ADDENDUM NO. 5

**LIBERTY INTERMEDIATE SCHOOL ADDITIONS
AND RENOVATIONS
Chesterton, IN 46304**

ADDENDUM FIVE

Addendum Five (AD.05) to the drawings and specifications prepared by Gibraltar Design for **Liberty Intermediate School Additions and Renovations** for Duneland School Corporation, Chesterton, Indiana.

S-105

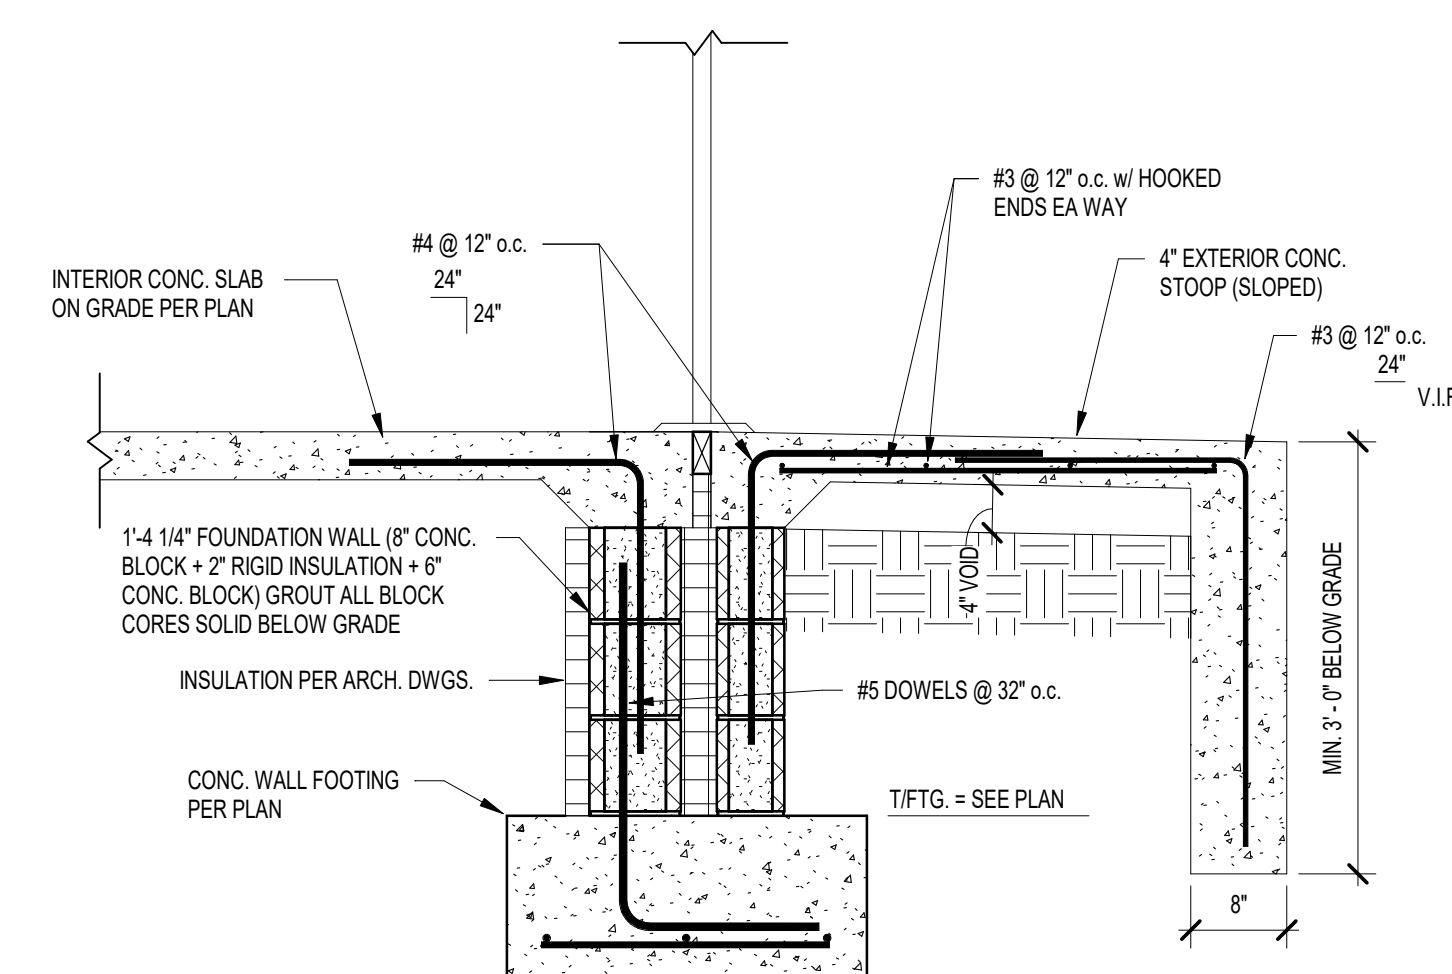
2. **Sheet S-105**
 - A. Refer to revised full-size drawing included in this Addendum, for revisions.
3. **Sheet S-402**
 - A. Refer to revised full-size drawing included in this Addendum, for revisions.

AD101

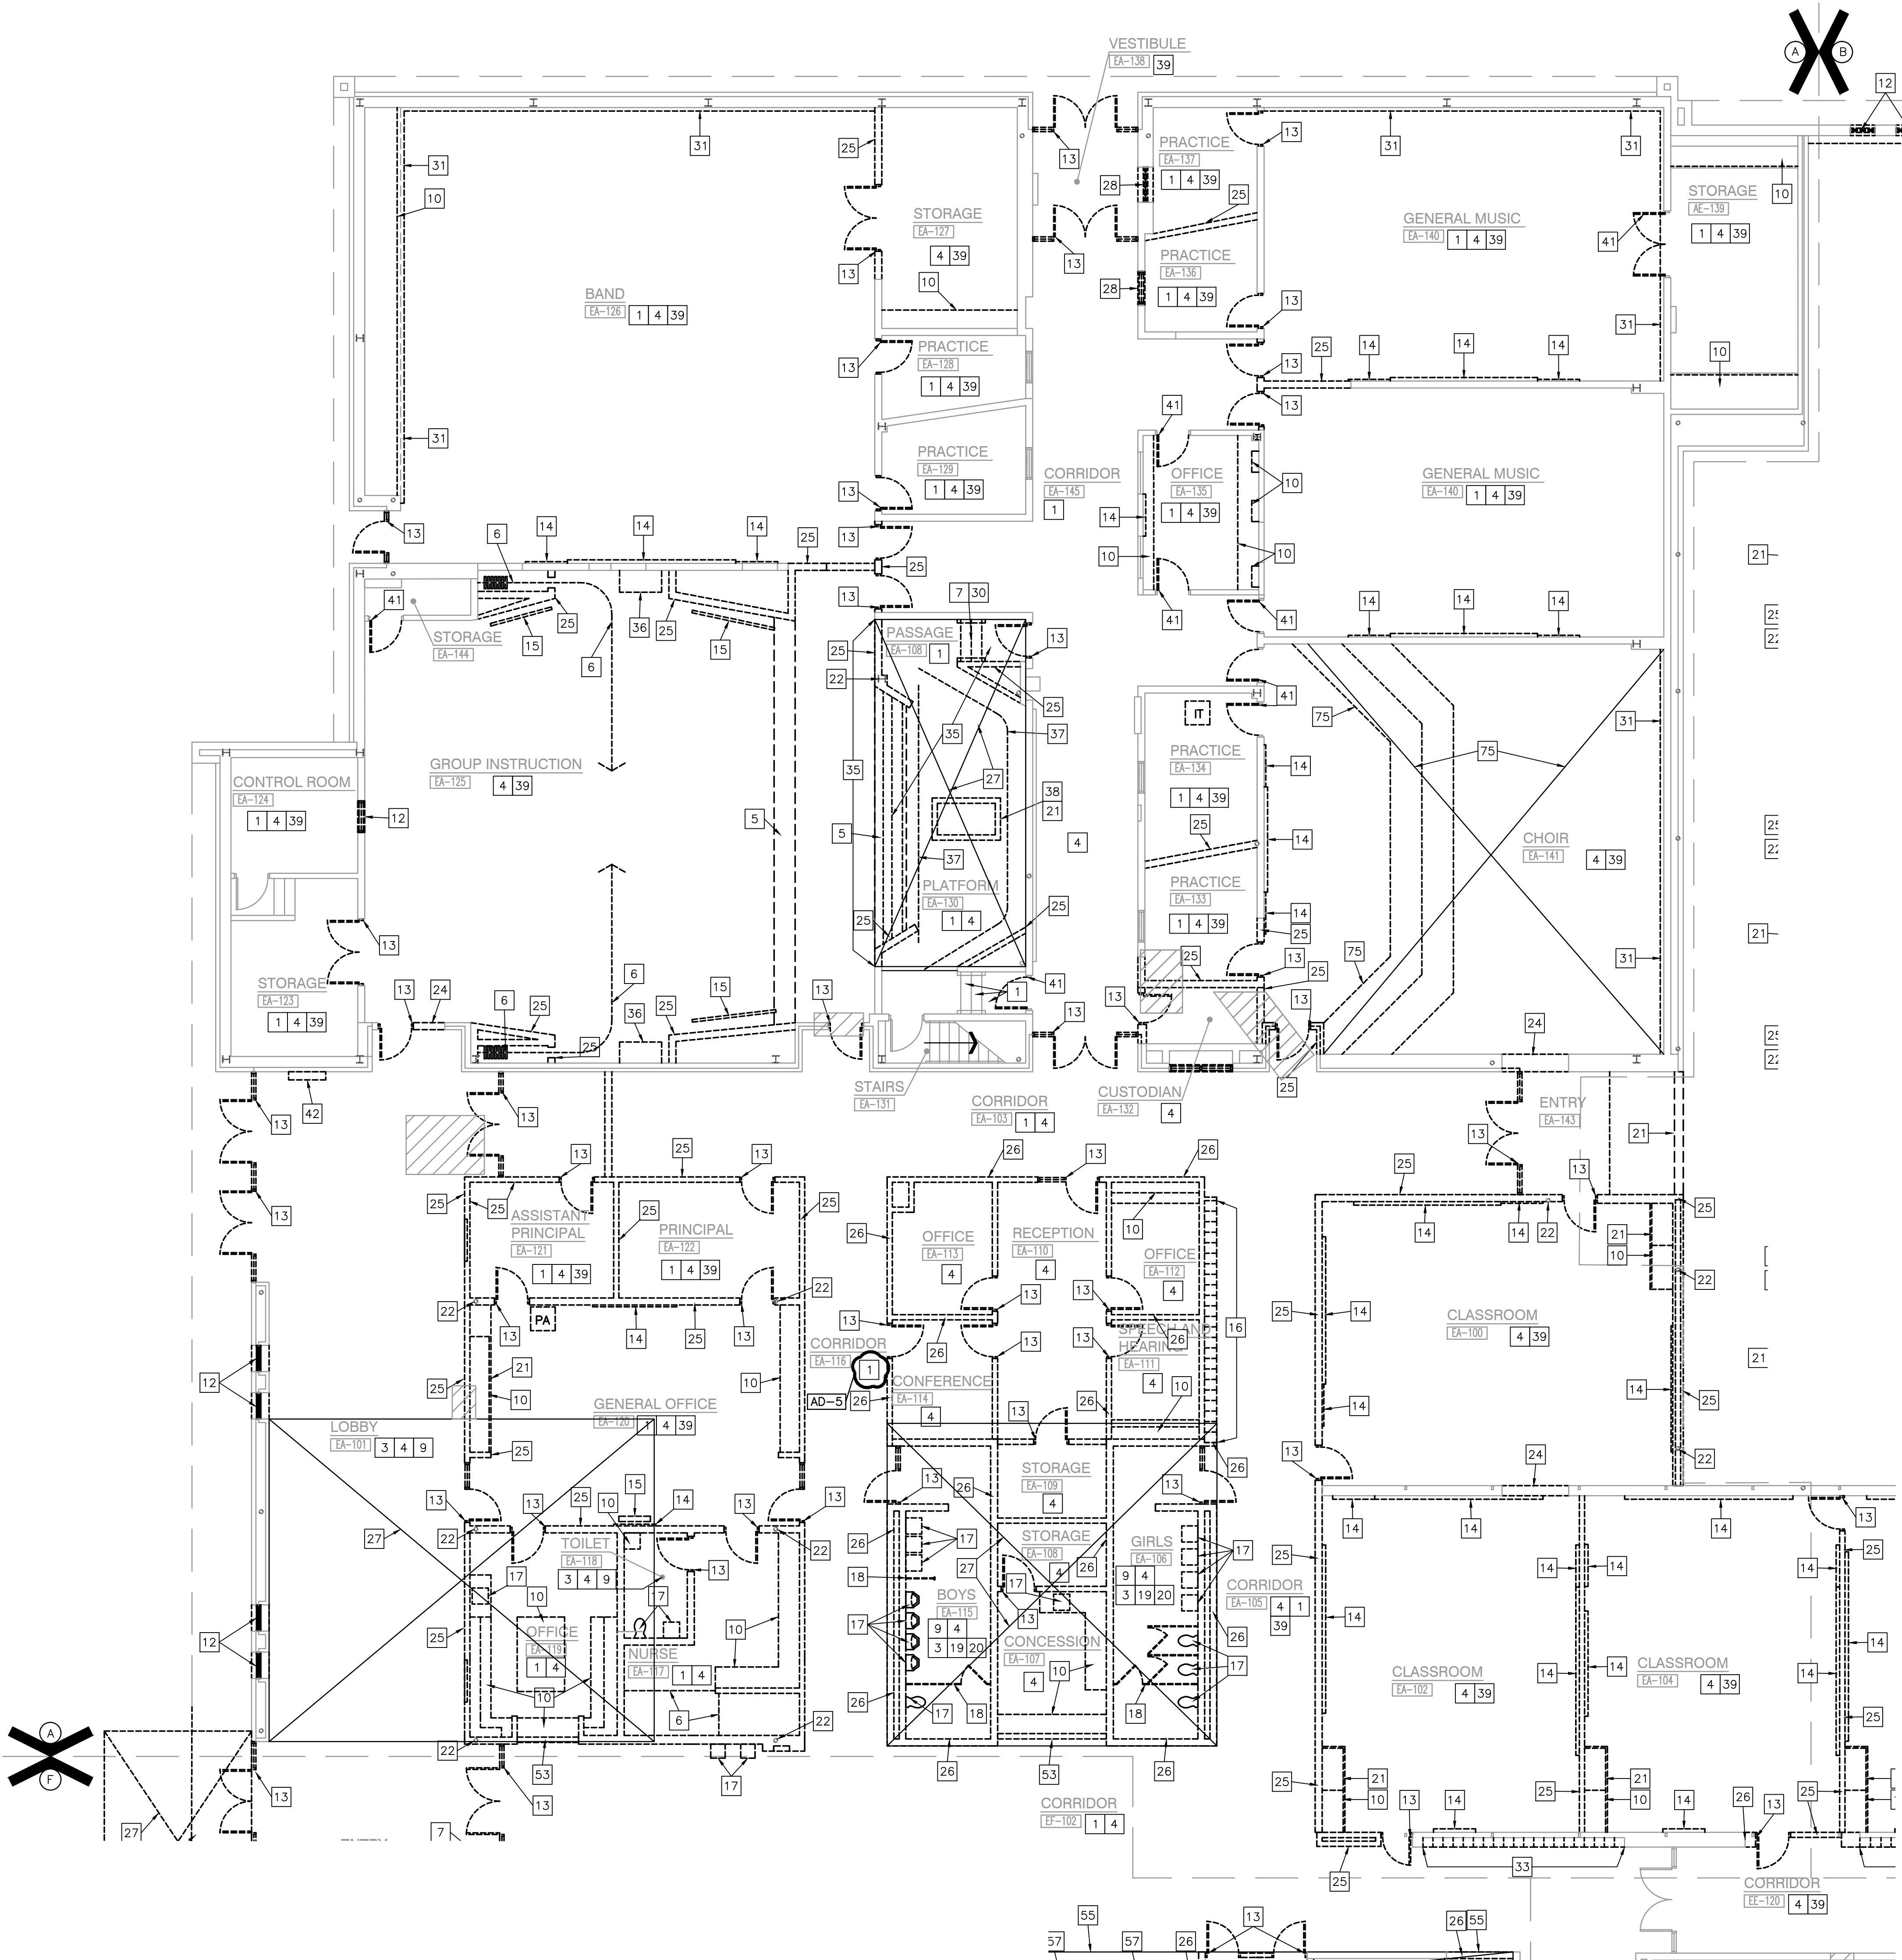
4. **Sheets AD101, AD105, AD106**
 - A. Refer to Three (3) revised full-size drawings included in this Addendum, for revisions.
5. **Sheets A-102, A-105**

A-102

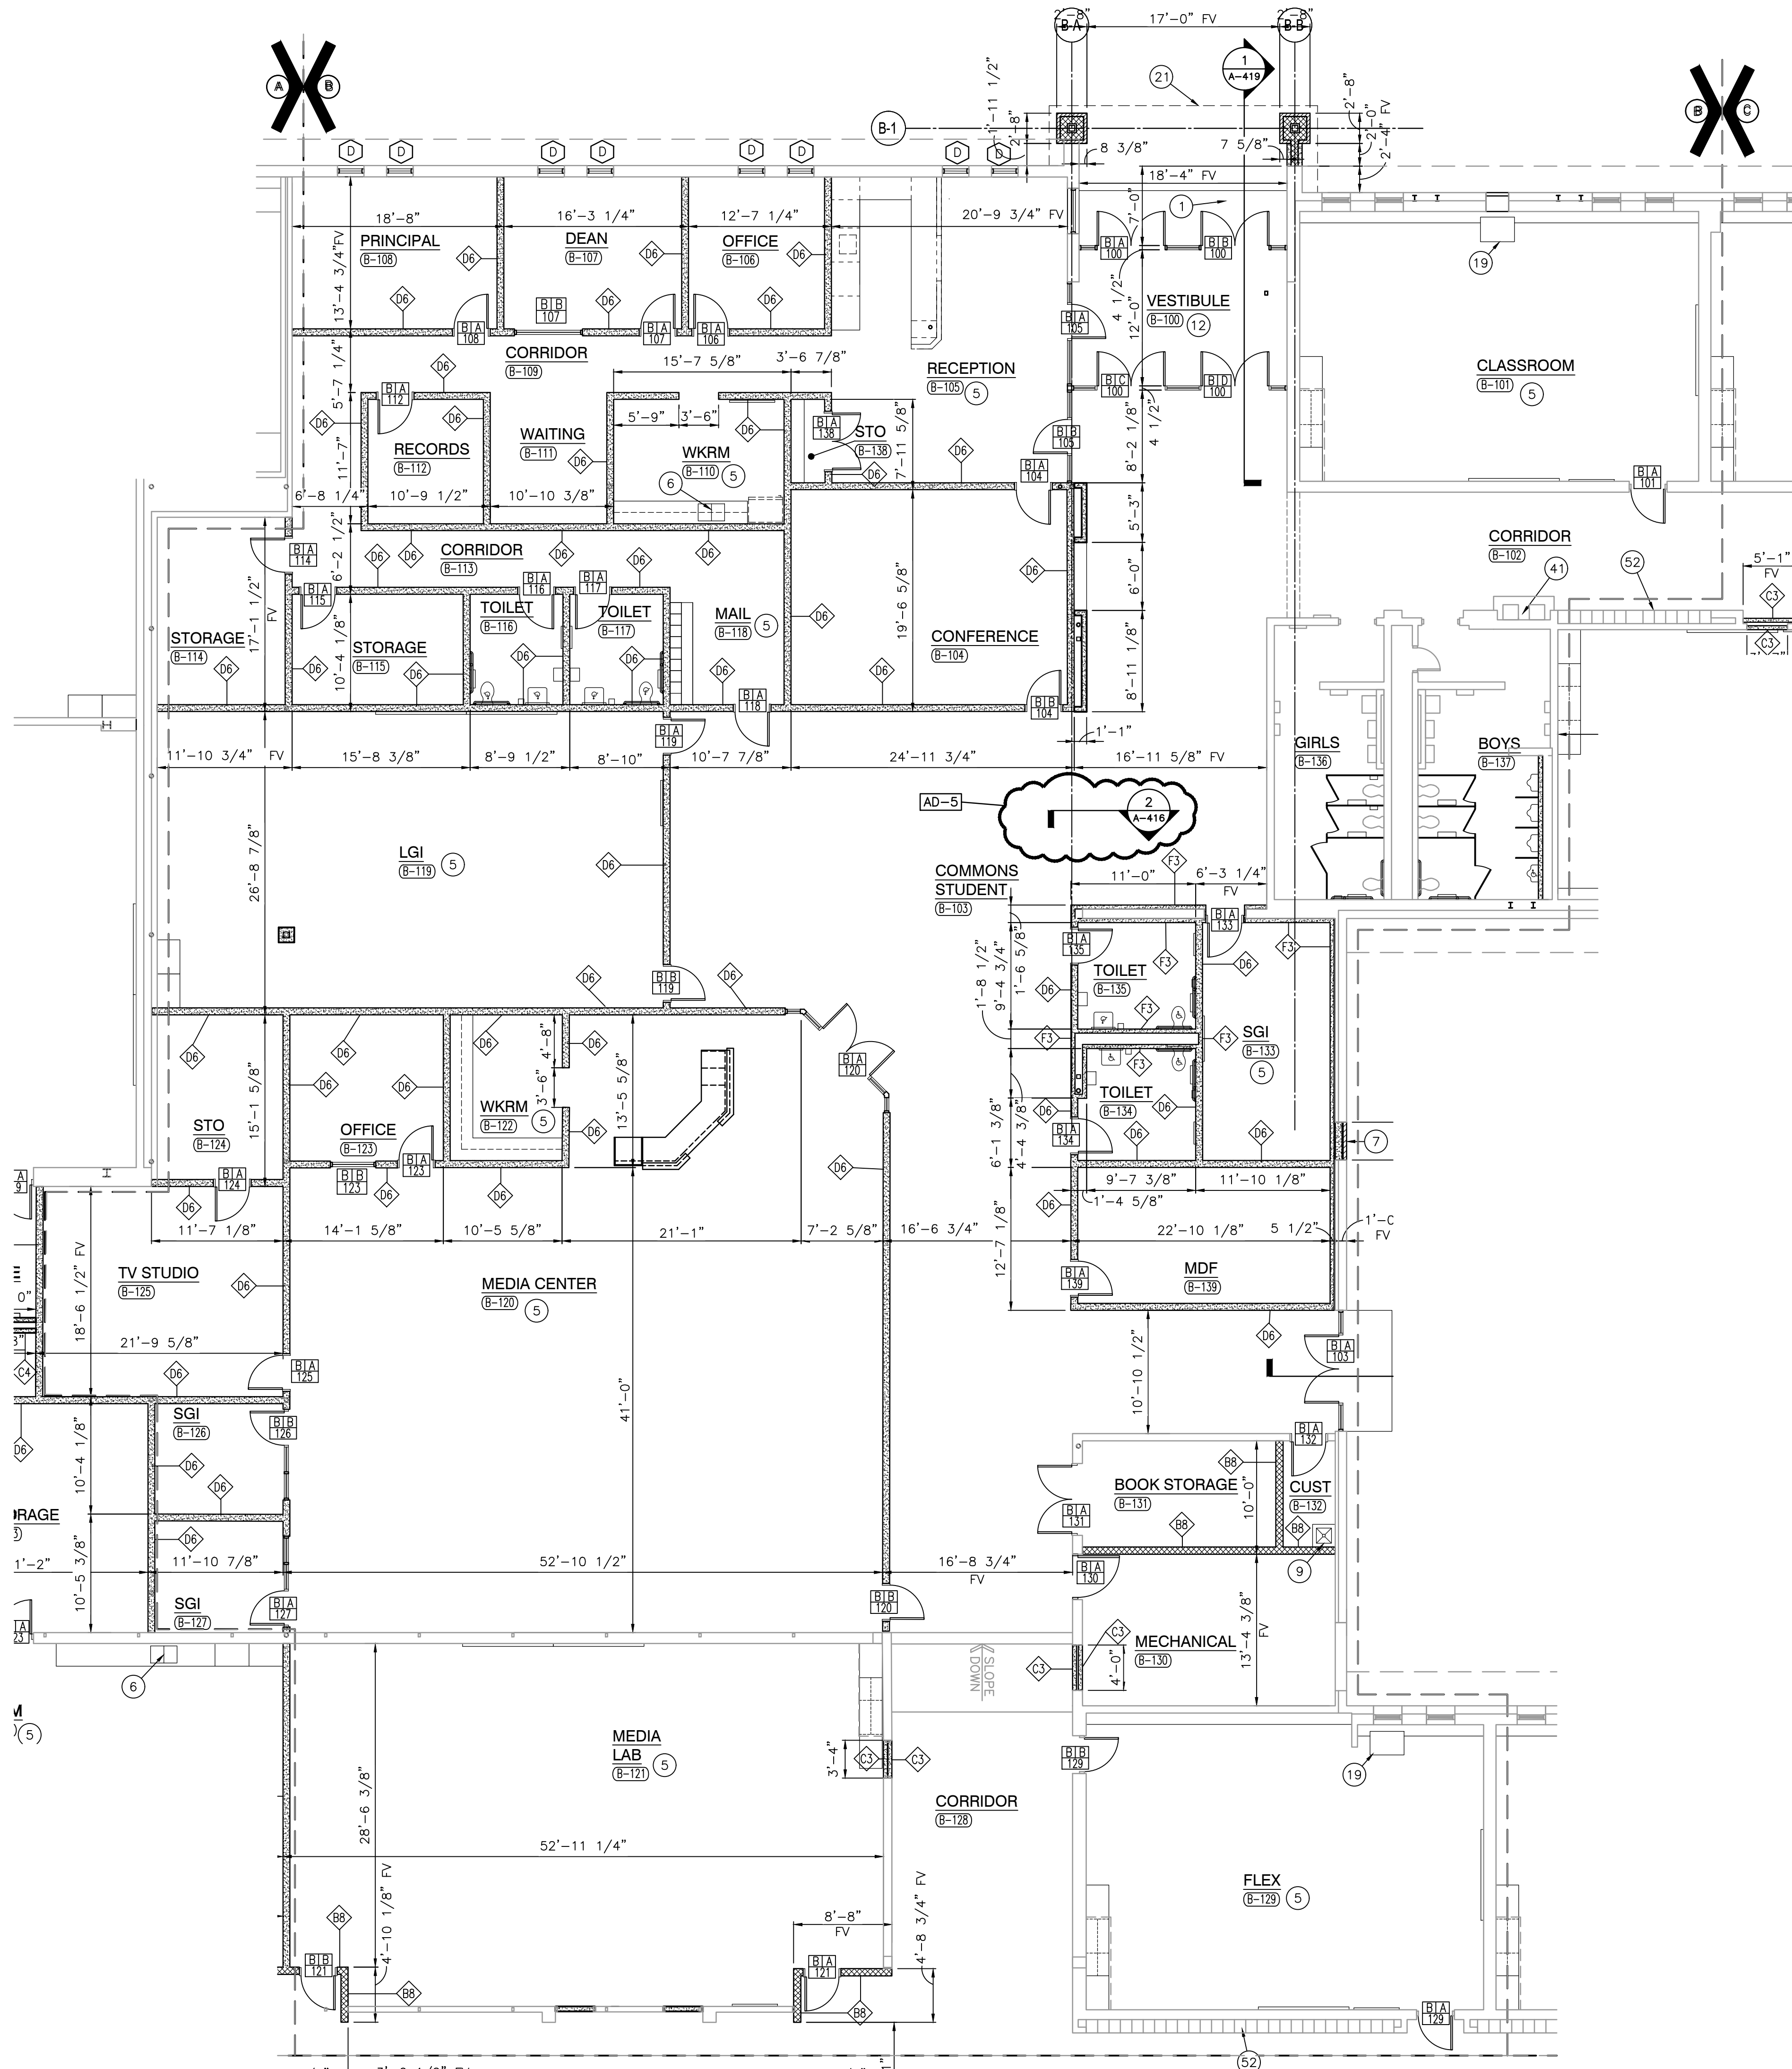
- A. Refer to Two (2) revised full-size drawings included in this Addendum, for revisions.
6. **Sheets A-408**
 - A. Refer to revised full-size drawing included in this Addendum, for revisions.
